ADDITIONAL BIDDERS QUESTIONS

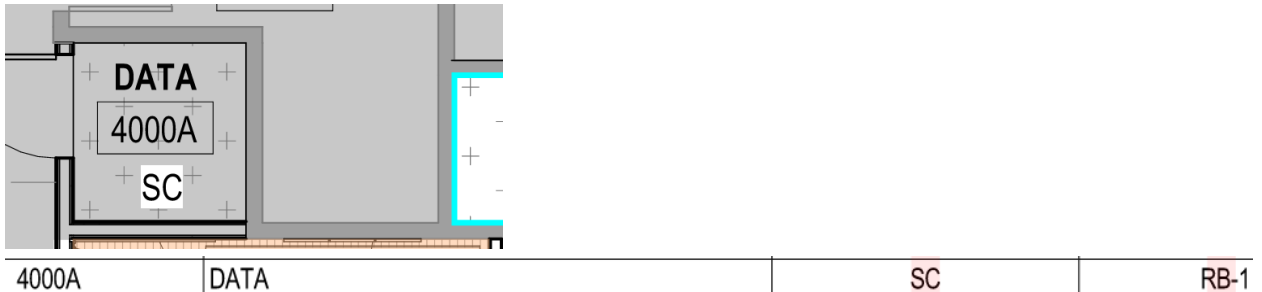
2- We believe that the color codes indicated in the finish schedule for CPT-2 and CPT-3 are incorrect. Could you please confirm that the products are correct as we have indicated below?

CPT-2	CARPET TILE	INTERFACE	ANGLE UP	107206	107188 SELENIUM	25cm X 1m
CPT-3	CARPET TILE	INTERFACE	ANGLE UP	107209	107191 CARBON	25cm X 1m

Answer: Yes, what you have noted is correct.

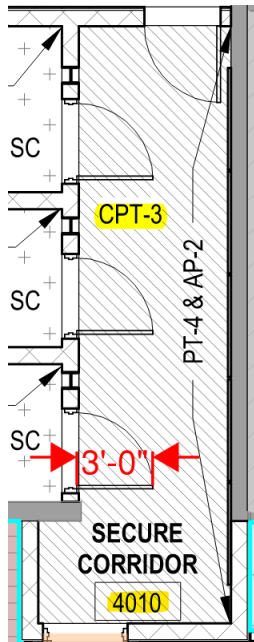
4- The 4000A Data area seems to be out of scope, but according to the room schedule, this area will receive SC and RB-1. Please confirm that we should proceed according to the room schedule for this area.

Answer: Yes, proceed as noted on the room schedule.

4010	SECURE CORRIDOR	SC	X
------	-----------------	----	---

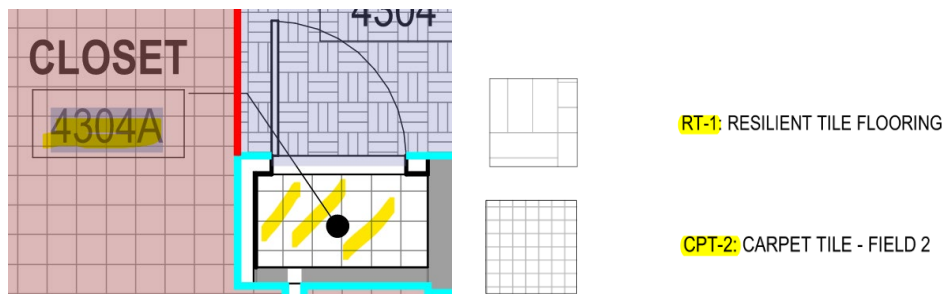
- 5- The 4010 Secure Corridor area is labeled as CPT-3 in the finish plan. However, this area will receive SC according to the room schedule. Please clarify which flooring material should be used.

Answer: Provide CPT-3, as shown on the finish floor plan.
